REV C 15 Jan 2021 GM/G  
 Planning Application further revised, see notes above  
 REV B 10 Aug 2020 GM/G  
 Revised Planning Application marked at Revision B  
 REV A 05 Dec 2019 GM/G  
 Original Planning Application marked at Revision A

PROJECT  
**The Hoo: Scheme 2**  
**17 Lyndhurst Gardens,**  
**Hampstead, London**  
 Returning a Grand Victorian House to Private Domestic Accommodation NW3 SNU

DRAWING  
**Lower Ground Floor Layout**  
**as Proposed**

JOB No	DRAWING No	REVISION
19013	1120	C
STATUS FOR PLANNING

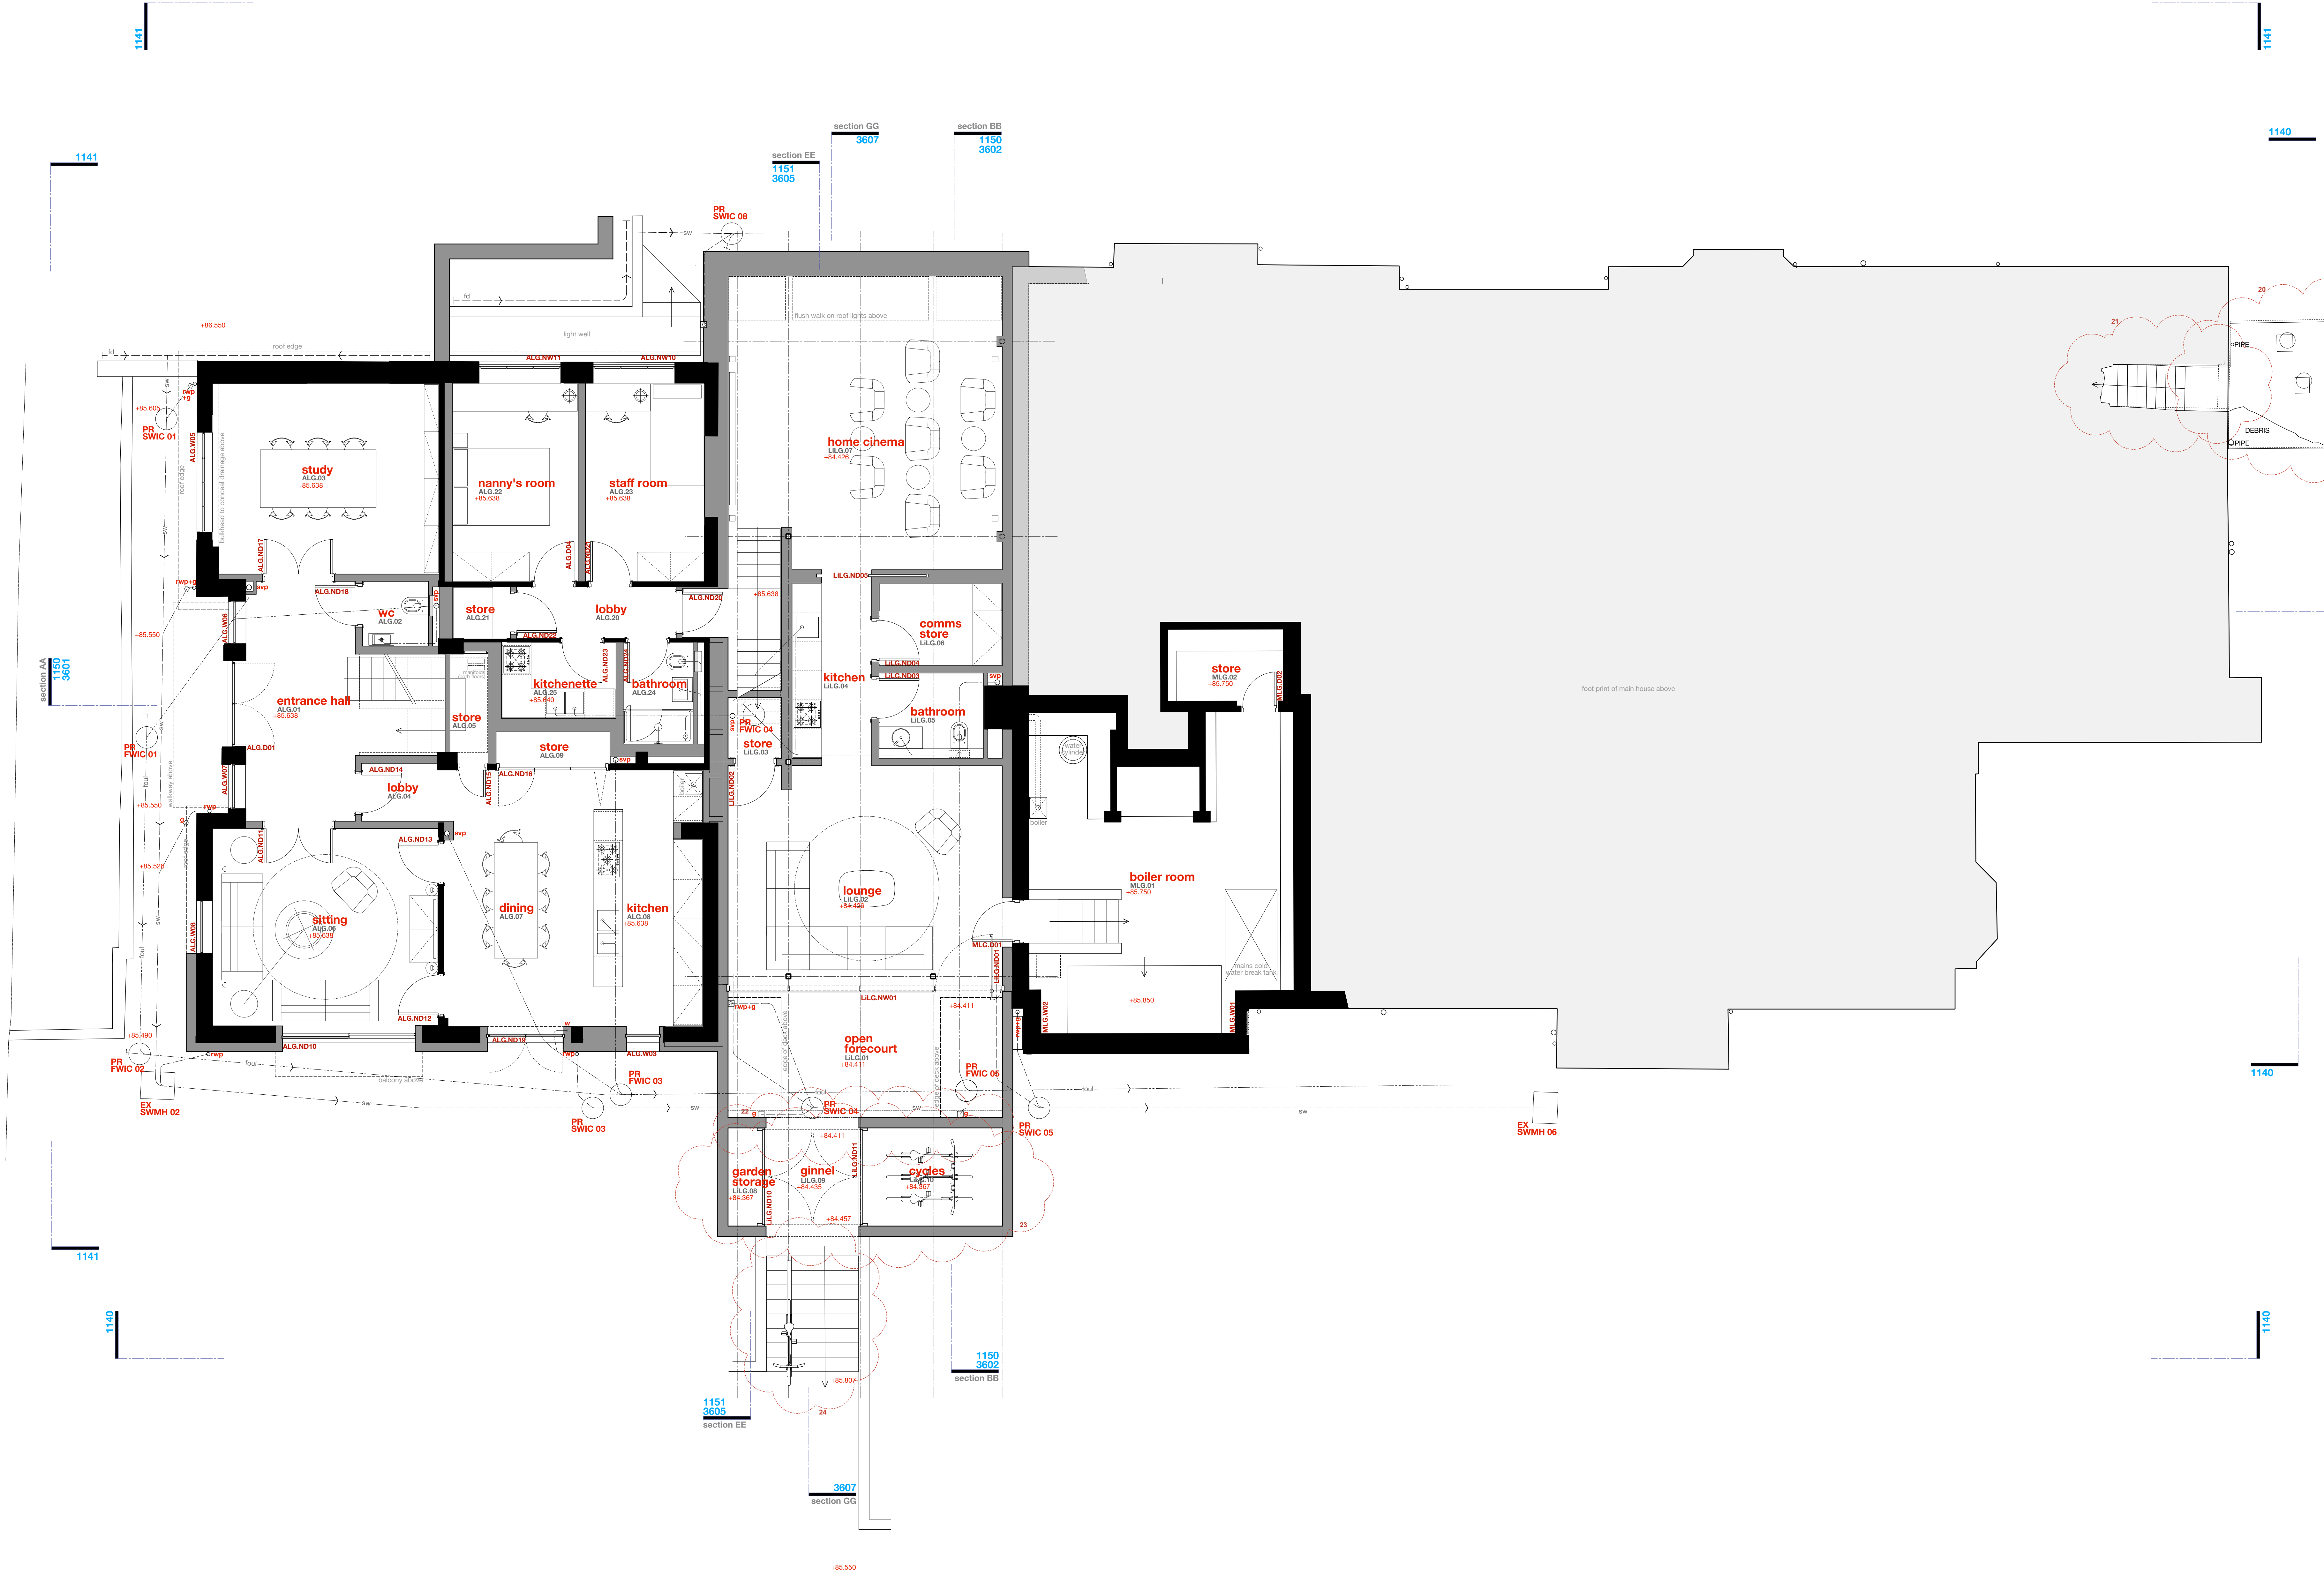
- mechanical: heating**
- gas fired boiler and wall mounted flue
  - unvented cylinder
- scheme 2 further revisions**
- 20 underground cellar is retained and stabilised as directed by the structural engineer and as appropriate and incorporated into the design.
  - 21 staircase is reinstated and repaired as necessary. staircase will be accessed via a floor hatch above.
  - 22 wall is moved to the north by 450mm to reduce the extent of subterranean construction located in front of the proposed link building.
  - 23 width of subterranean storage is significantly reduced in width by 200mm to reduce the amount of subterranean construction in front of the proposed link building by 1462mm.
  - 24 external slab is moved by 1462mm to the north with reduction of subterranean structure.

**DRAWING**  
 Ground Floor Layout  
 as Proposed

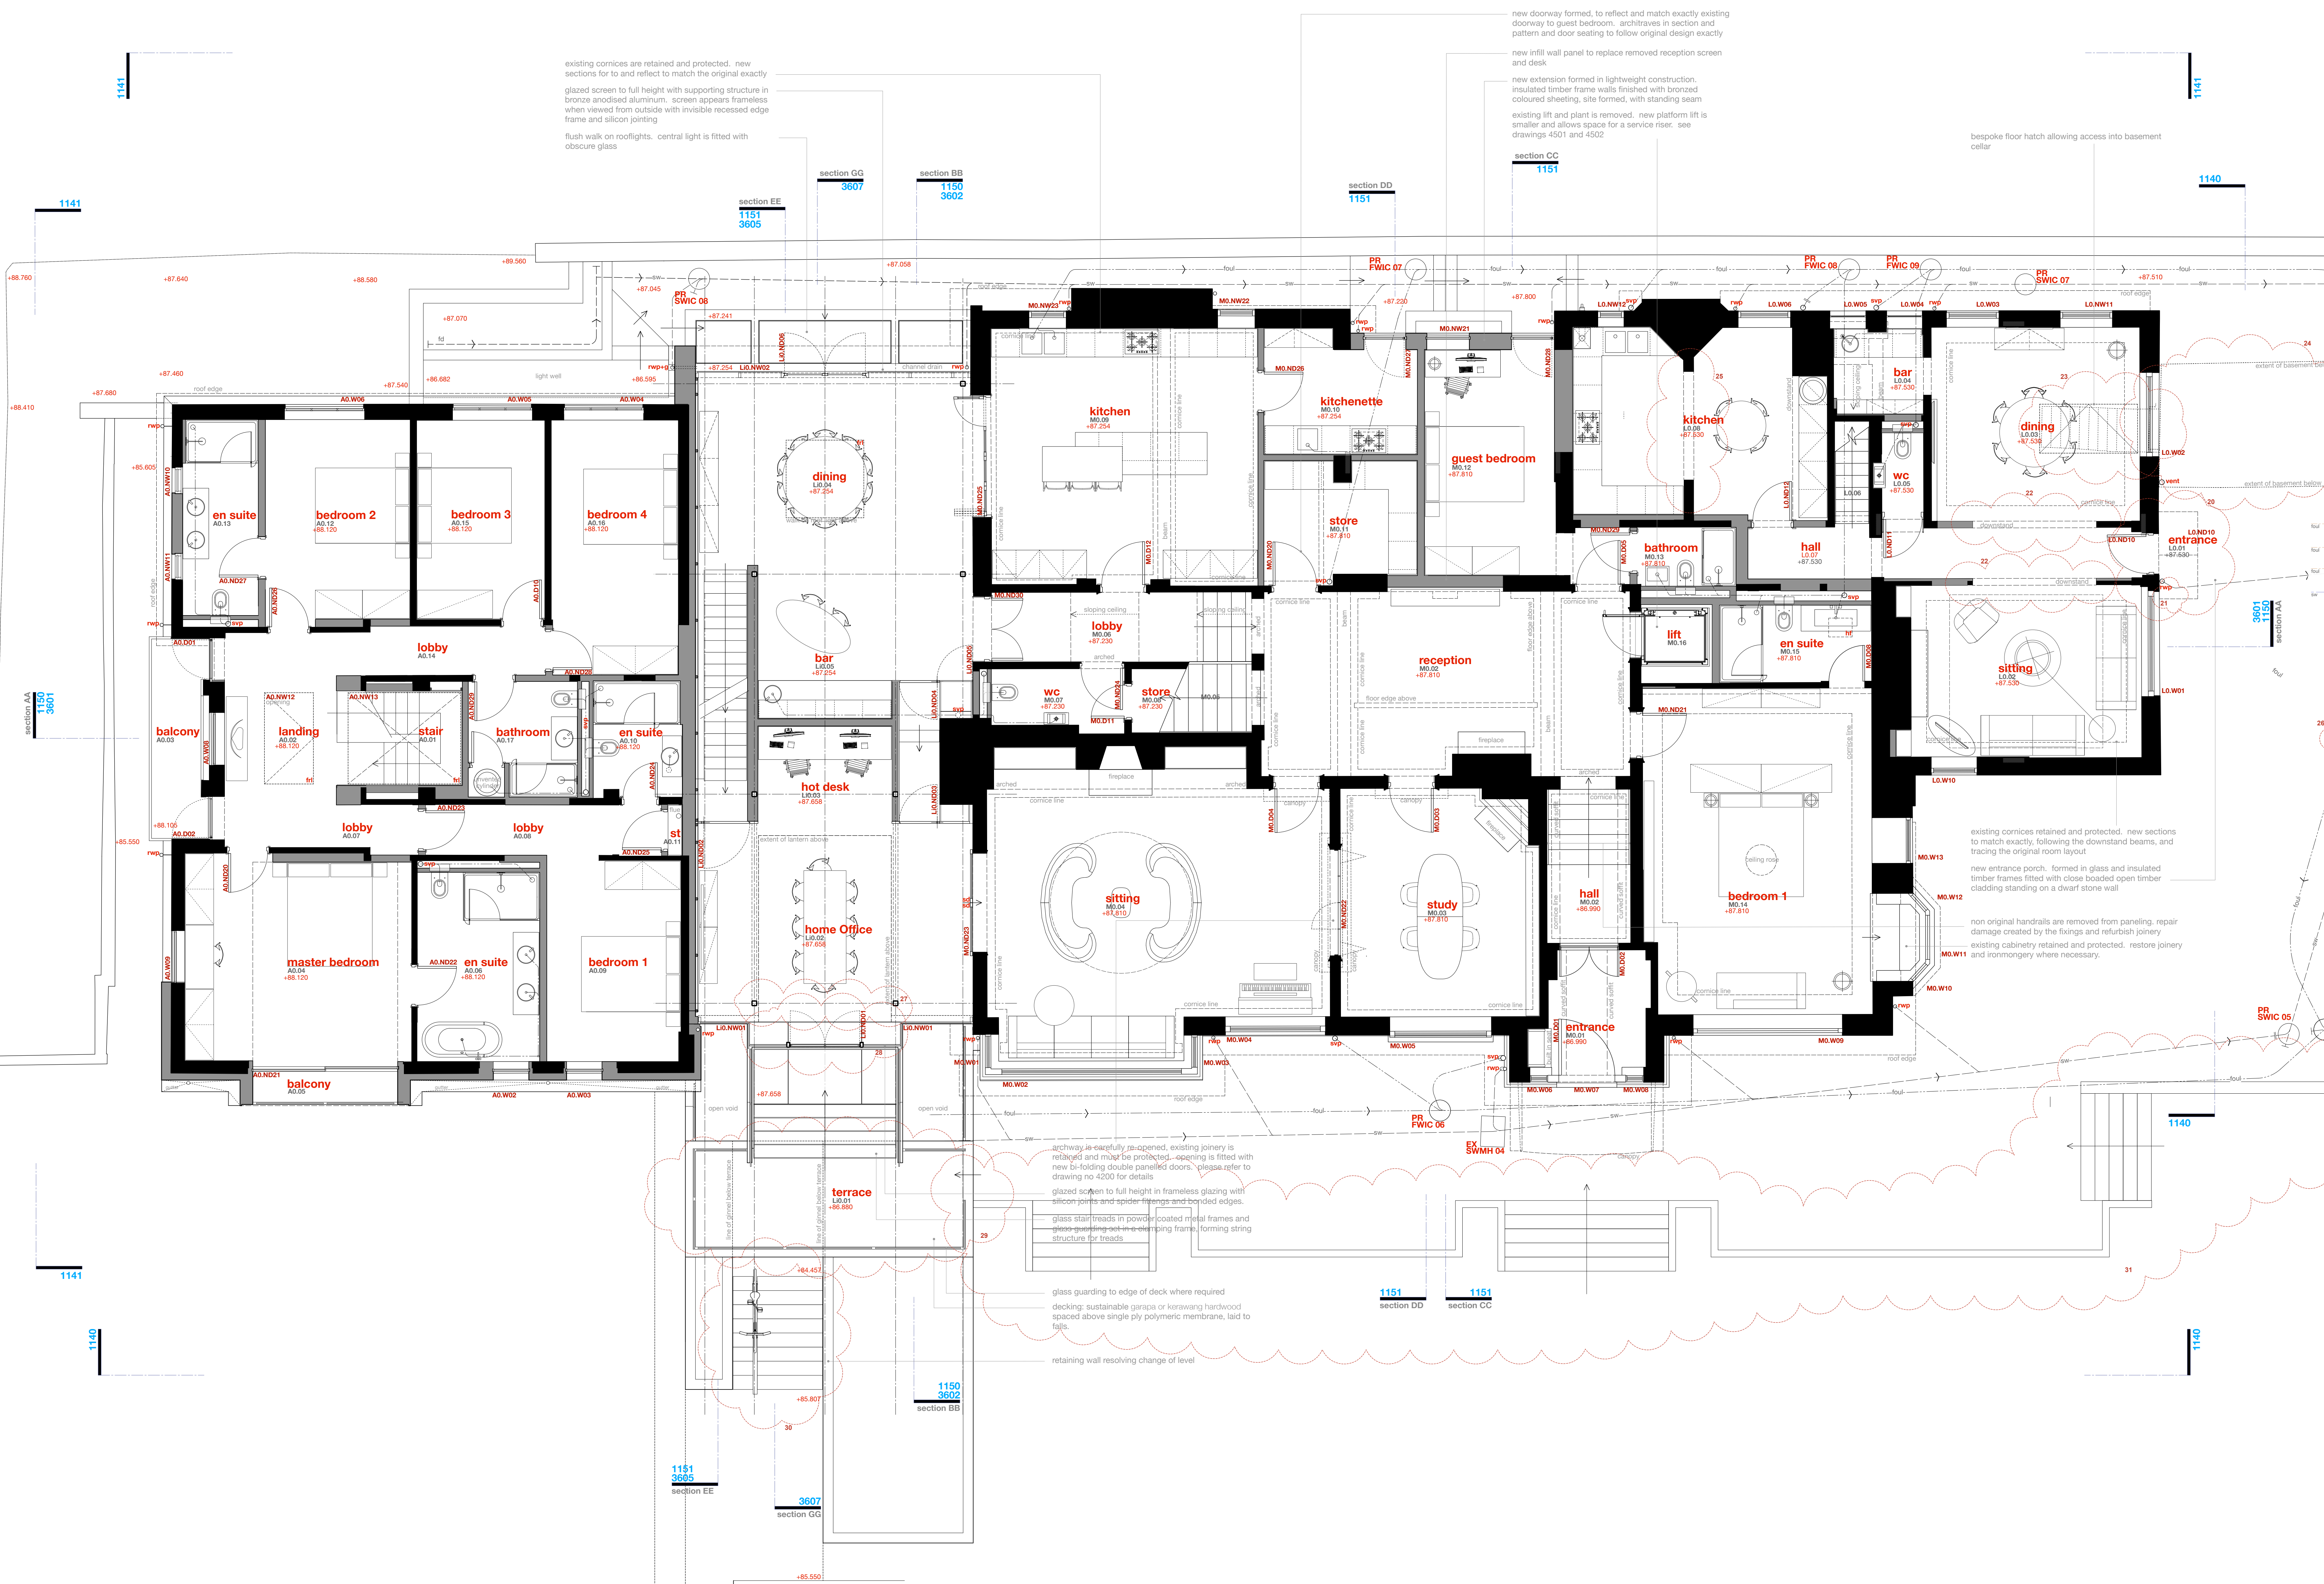
- scheme 2 further revisions**
- proposed porch removed and existing canopy is retained. new roof door and seal installed
  - non original sep removed from principal facade, change re-located to north elevation

- coverings are reduced and lowered to include more original fabric, glass presentation boxes are removed
  - floor hatch providing access to underground cellar

- underground cellar is retained and established as appropriate and incorporated into the design
  - length of ribs are increased to retain more original fabric and the sense of separation

- new marking position removed as a consequence of 21 (skew)
  - gill line and structure moved slightly northwards
  - depth of glass bay reduced by 200mm to recess structure from principal facade of historic building

- terrace structure is significantly reduced in width by 1012mm to reduce the amount of submerge construction in form of the proposed fire building, south face is located 1460mm further northwards

- external stair is moved by 1460mm to the north with reduction of submerged terrace structure
  - terrace structure is removed to allow increased green space and match the latest landscape proposals
